Well Name: PAC TEN	Well Location: T24N / R9W / SEC 7 / SESE / 36.323318 / -107.823425	County or Parish/State: SAN JUAN / NM
Well Number: 1	Type of Well: OIL WELL	Allottee or Tribe Name:
Lease Number: NMNM45207	Unit or CA Name:	Unit or CA Number:
US Well Number: 300452591700S1	Operator: DUGAN PRODUCTION CORPORATION

Notice of Intent

Notice of Intent – Plug and Abandonment

BLM - FFO - Geologic Report**Date Completed** 12/5/2024

Pac Ten #1

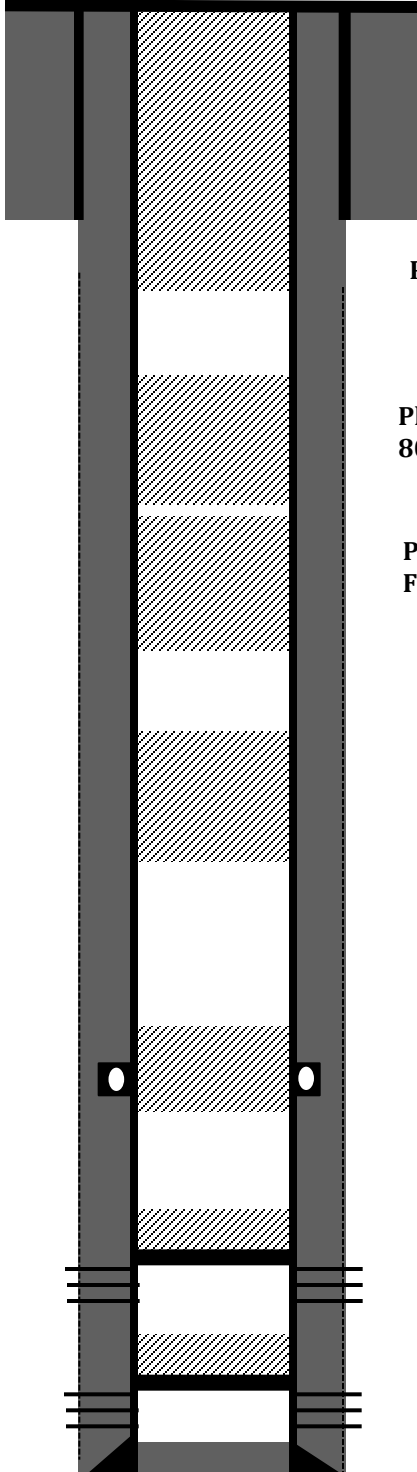
-Divide Plug 4 into two plugs to account for the BLM geologist's picks for the Cliff House and lower Chacra. Cover the Cliff House from 3040' to 3190'. Cover the lower Chacra from 2585' to 2435'. Alternatively, a single plug from 2435' to 3190' would be acceptable.

Created By	Condition	Condition Date
mkuehling	NMOCD agrees with BLM on formation tops - Gallup plug needs to be extended to 5200 - add upper chacra plug - Notify NMOCD 24 hours prior to moving on - Monitor string pressures daily report on subsequent - submit all logs prior to subsequent	12/10/2024
